SERVICETEKNOTES

TABLE OF CONTENTS

Change DC Subsystem amplifier schematic as shown below:

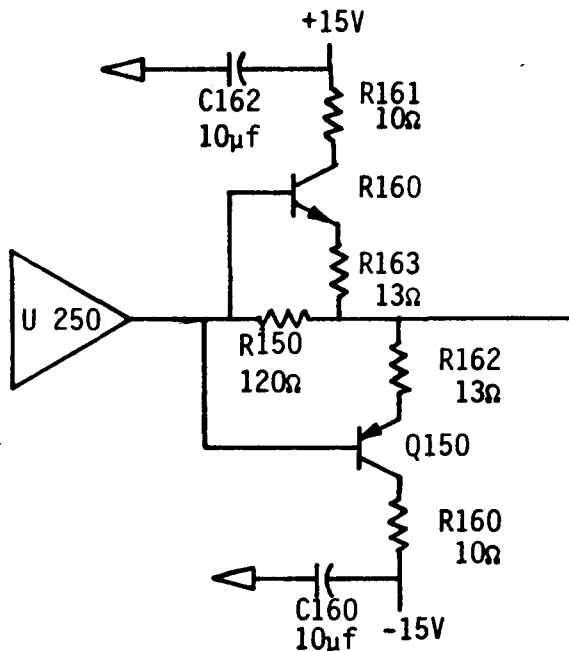
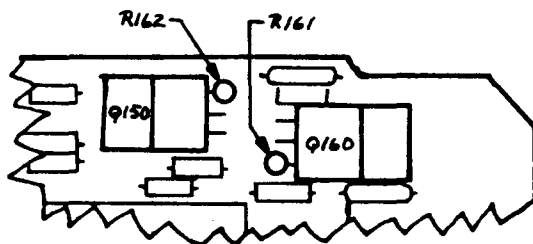
The DC Subsystem amplifier oscillates at about 10 MHz. This occurs while measuring current on the 100 ma range with VS3 or VS4 set greater than + or - 1.8 volts and with a load of about 100 ohms from I pin to system ground. The oscillations are enveloped by about a 60 Hz rate on domestic systems. The problem is sensitive to common bus capacitance and has mostly been seen on systems with CF-1. In order to see the problem on systems without CF-1, it is sometimes necessary to add several feet of cable (capacitance) in the common bus line. The following paragraph and circuit view describe how the circuit is to be modified to significantly reduce the oscillations.

Change Q150 from a 151-0364-00 to a 151-0366-00. This will make a better match of Q150 and Q160. Change R150 from 47 ohm, 1/4W, 5%, 315-0470-00 to a 120 ohm, 1/4W, 5%, 315-0121-00. Add R162 and R163 resistors 13 ohm, 1/4W, 5% 315-0130-00. This will dampen the oscillations

which are caused by the cascaded emitter follower (U250, Q150, and Q160 connections).

Install R161 & R162 on DCSS Amplifier as shown below

TM5003/TM5006 OSCILLATOR I.C.
REPLACEMENT OR OSCILLATOR FREQUENCY
INCORRECT

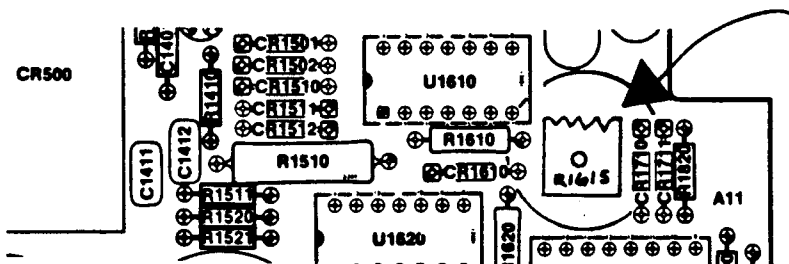
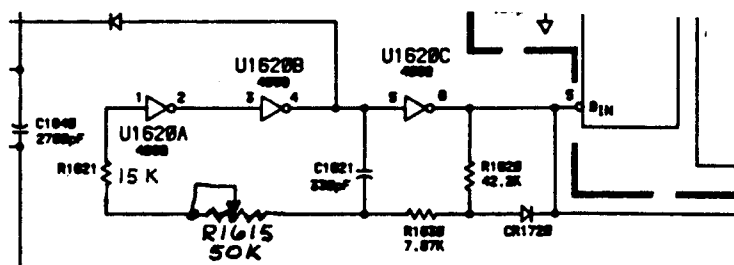
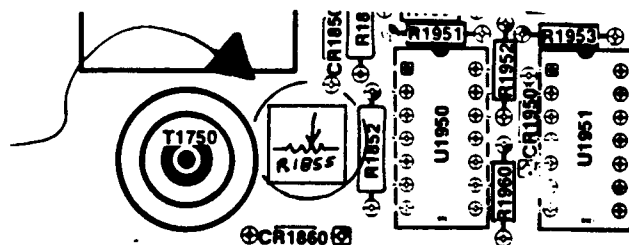
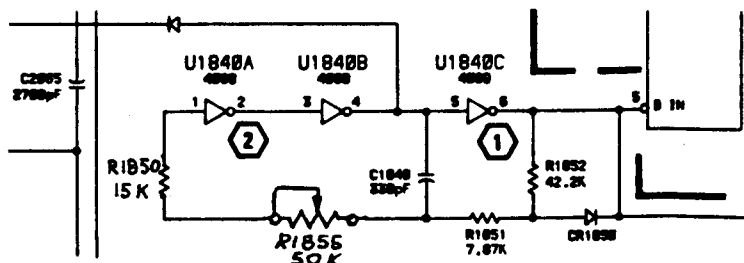
Damage can occur to the switching transistors Q1300 or Q1301, TM5003, (Q1640 or Q1650, TM5006) if the oscillator frequency of the TM5000 mainframe does not meet the 40 kHz to 42 kHz specification as tested at R1510 (R1860). A symptom of an audible high pitch noise indicates

the oscillator is off frequency. Batch variances of the oscillator I.C. U1620 (U1840) P/N 156-0745-00 can cause the oscillator frequency not to meet specification. If it is determined the frequency is not correct or when replacing U1620 (U1840) the following changes should be made.

1. Change A11R1621 (R1850) to P/N 321-0306-00 15K ohm 1/4W
2. Remove A11W1630 (W1860) Dummy Resistor
3. Add A11R1615 (R1855) P/N 311-1232-00 50K ohm var. resistor.

The holes provided for the var. resistor are located above the removed dummy resistor. Caution, the holes provided are not the holes left by the removal of the dummy resistor, but are holes already provided for the variable resistor. The part is keyed to be inserted only one way (see diagram for the part location).

Figure 1
SAFETY LABELS

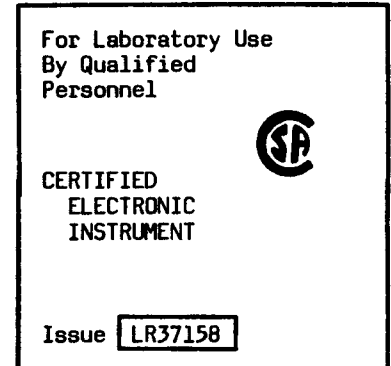
Starting at B010180 (690SR) or B010647 (6942) several labels have been added to the mainframe. Figure 1 illustrates the three safety certification labels that will be used. Labels 1A & C will be found on 690SR instruments in most applications, and labels 1B & C will be found on 6942 instruments and some 690SR options.

Figure 3

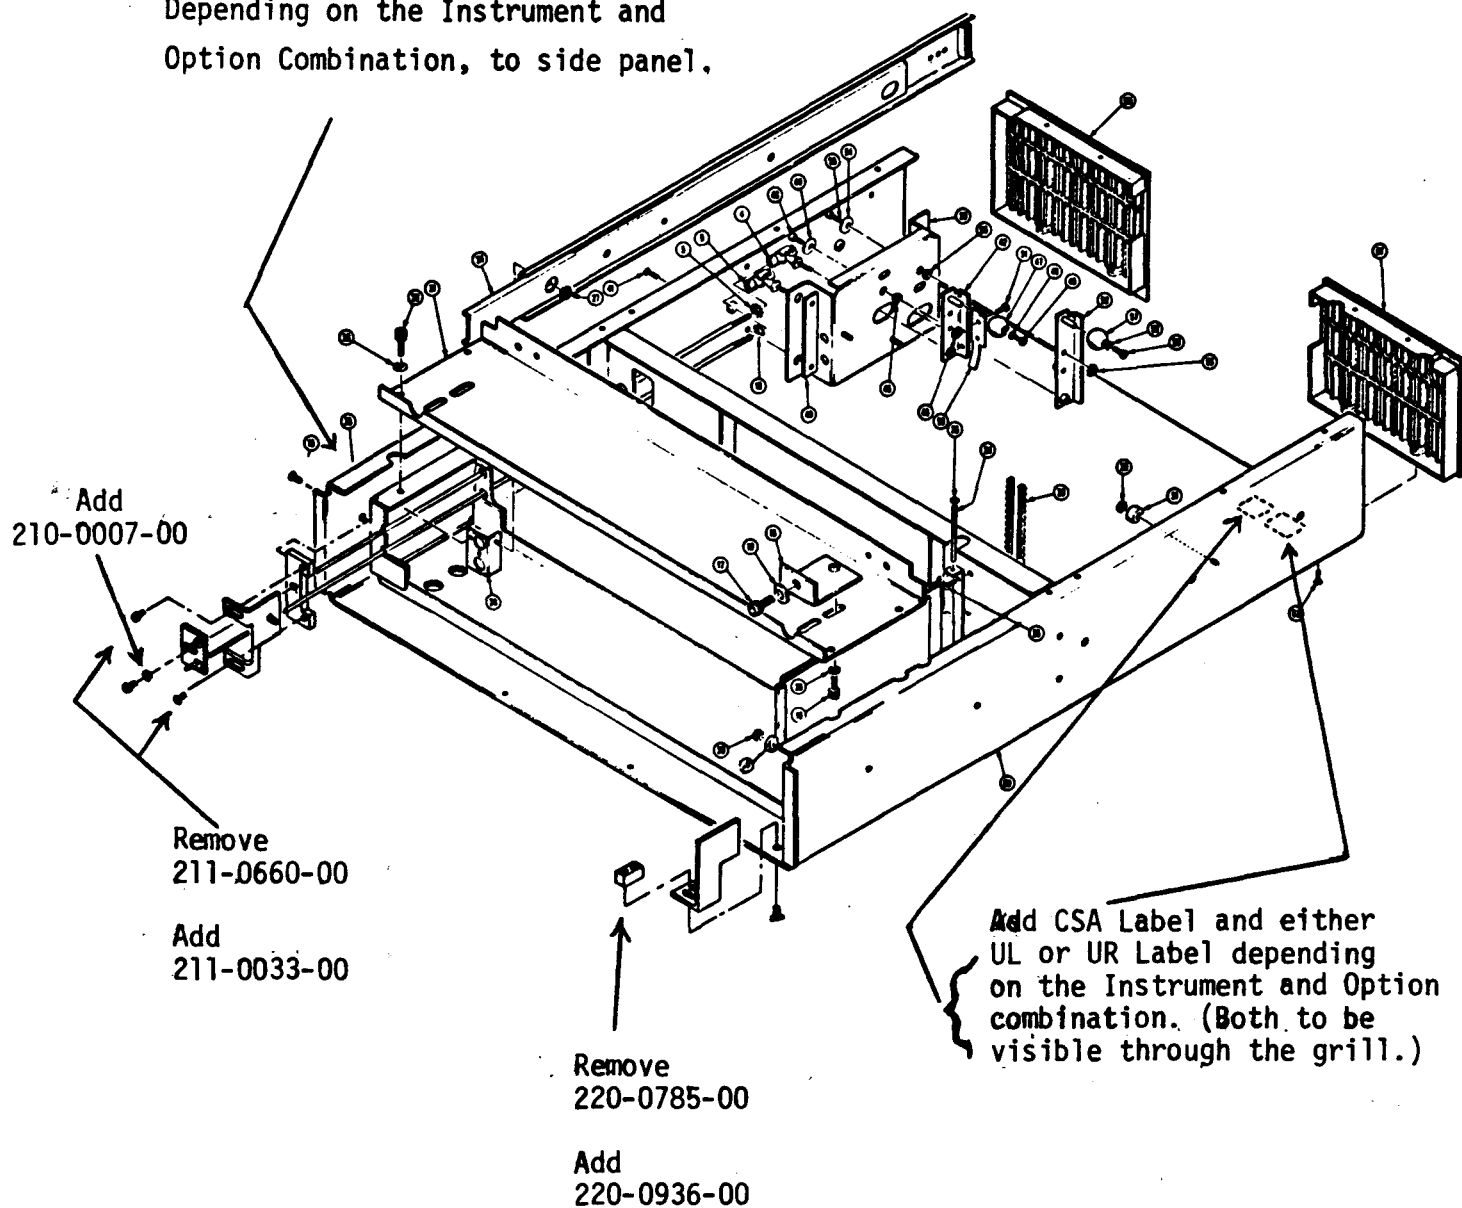
These labels are located at the rear of the bottom chassis as per Figure 3. These labels are not field replaceable. If one of these labels is damaged and must be replaced for customer requirements, the instrument must be returned to the factory. Contact Factory Service and arrange for the instrument to be sent in for recertification on the manufacturing line.

Figure 2 illustrates two labels, one of which will be located on the Front left side of the bottom chassis as per Figure 3. Label 2A will be installed on 690SR's sold into the television marketplace, and label 2B will be installed on 690SR's installed in data display applications, particularly Opt. 40 and 48. These labels call out the appropriate Horizontal scan rate for instrument calibration.

ADDED: (1) 334-4861-00 (TV Rate) or
(1) 334-4862-00 (Horiz rate)
Depending on the Instrument and
Option Combination, to side panel.

FIGURE A

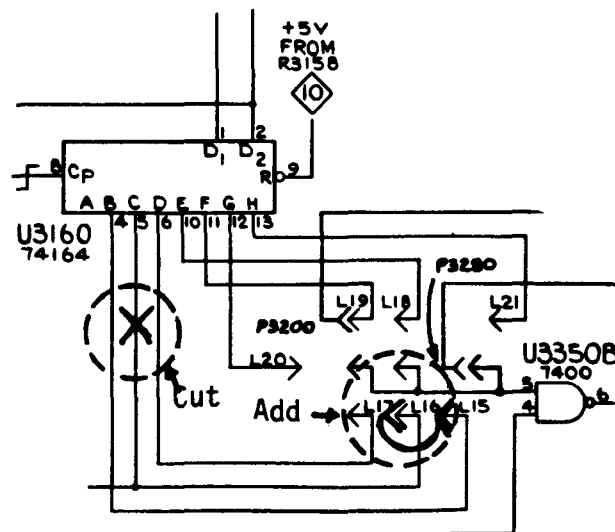
interval. A temporary solution for the problem was suggested, consisting of changing the value of R7200 to about 25K ohms.

Vertical insertion width adjustment can be modified to allow passage of lines 15 and 16 by replacing R7200 with an 18.2K ohm resistor, and then

adjusting R7205 for the desired insertion/deletion parameters.

Figure A illustrates the modification for setup timing, and figure B illustrates the modification for insertion timing.
